190433(54) BJ/LF

8th March 2022

**PROPOSED S4.55 (1A) MODIFICATION
OF DA18-1393
TORRENS TITLE SUBDIVISION
TWO (2) LOTS INTO 20 LOTS (STAGE 54)**

Figure 2: Stage 54 Current and Proposed Layout

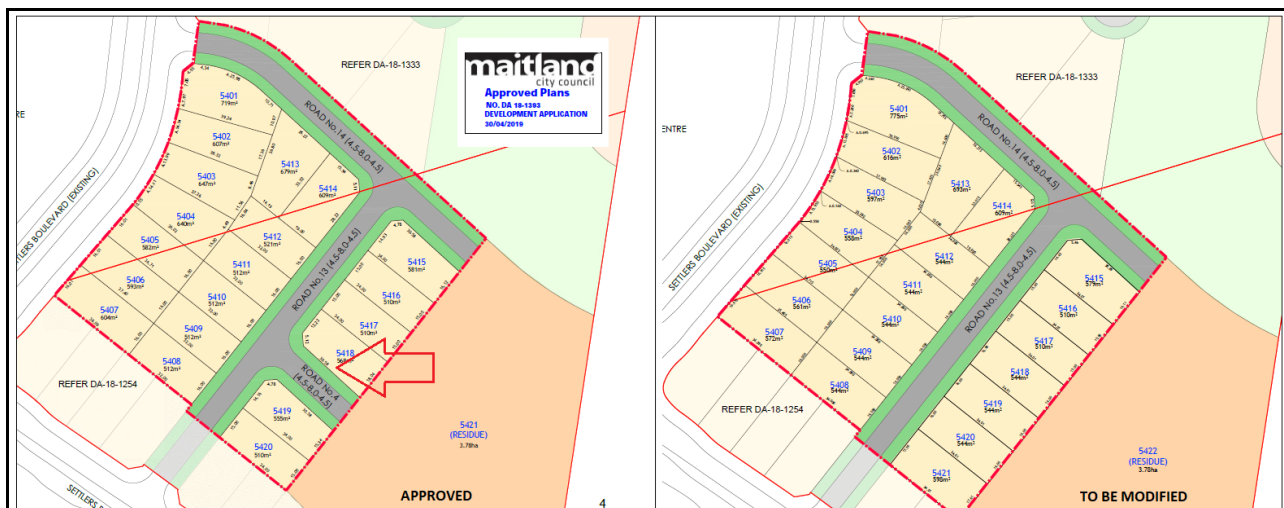
Since consent was issued to the subject DA, a subdivision pattern over Lot 4 DP1145348 (DA/2021/1662) has been resolved, which has allowed for the design and development of Stage 56 to proceed. In preparing this design and the road layout, it became apparent that a more efficient layout could be achieved by removing Regina Way (approved as "Road No. 4"), and creating an additional allotment.

The approved and amended layout are provided within Figure 2.

Figure 3: Stage 54 Approved and Proposed Earthworks

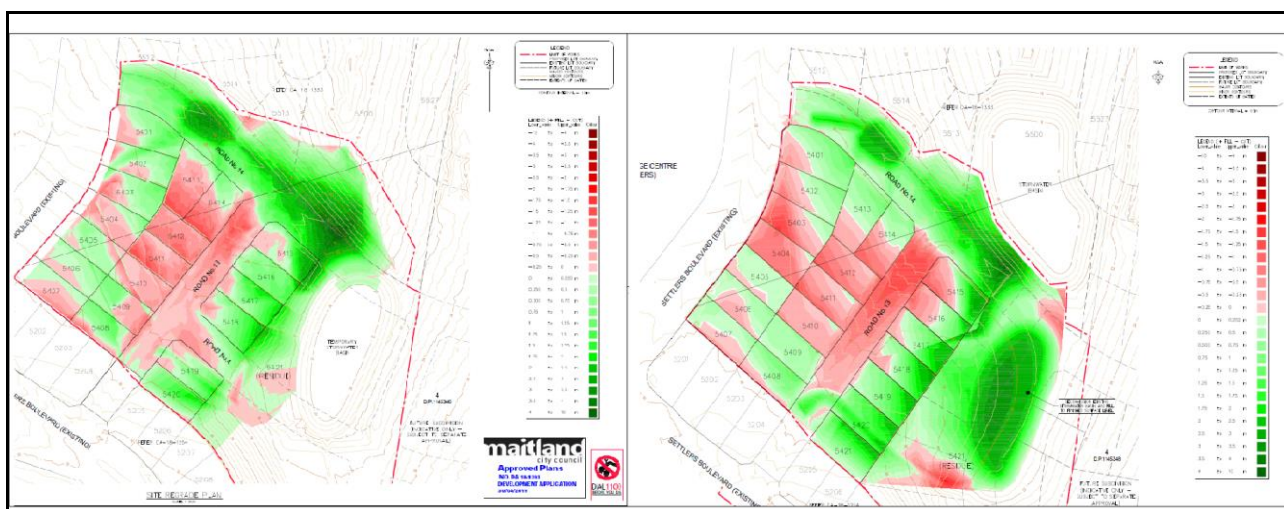
The proposed amendments also include amended regrading and the addition of retaining walls of up to 0.6m along the side boundaries of Lots 5404-5406, up to 1.25m along the side boundaries of Lots 5401 and Lots 5408-5421 and up to 2m along the rear of Lots 5416-5421.

The approved and amended earthworks and retaining are provided within Figures 3 and 4.

Figure 4: Stage 54 Approved and Proposed Retaining

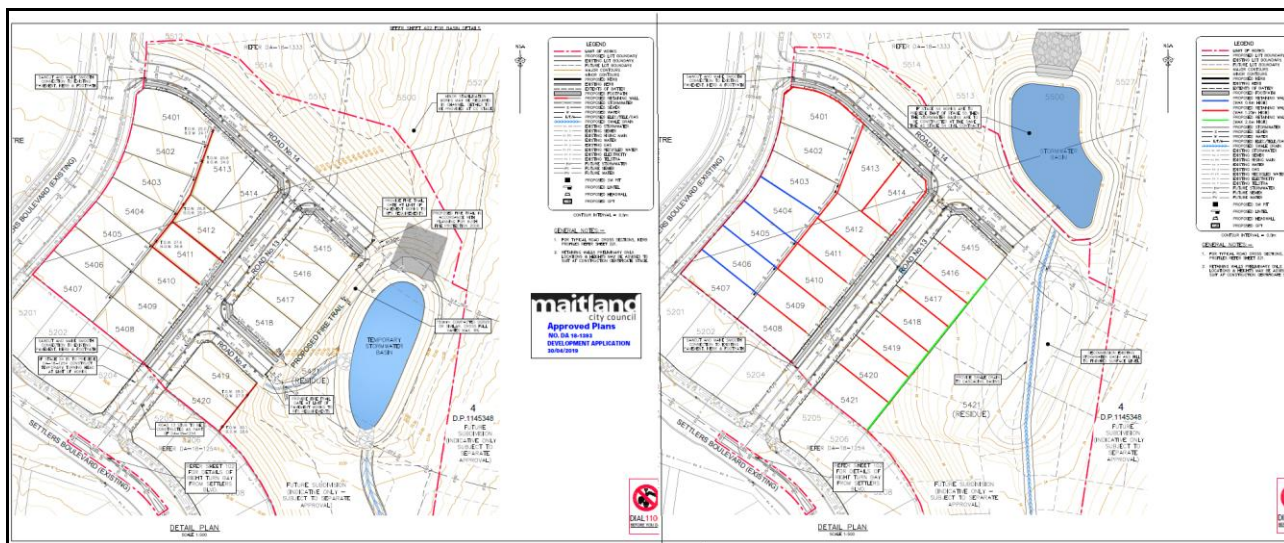
Stormwater generated under Stage 54 was previously approved to discharge over a temporary basin located within the residue lot (Stage 56). Due to the decommissioning and removal of the temporary stormwater basin to accommodate Stage 56, stormwater from Stage 54 will be treated by the third stormwater basin proposed under Stage 55. Should Stage 54 works precede Stage 55, the third basin will be built at the same time as Stage 54.

The approved and proposed stormwater management for Stage 54 is provided within Figure 4.
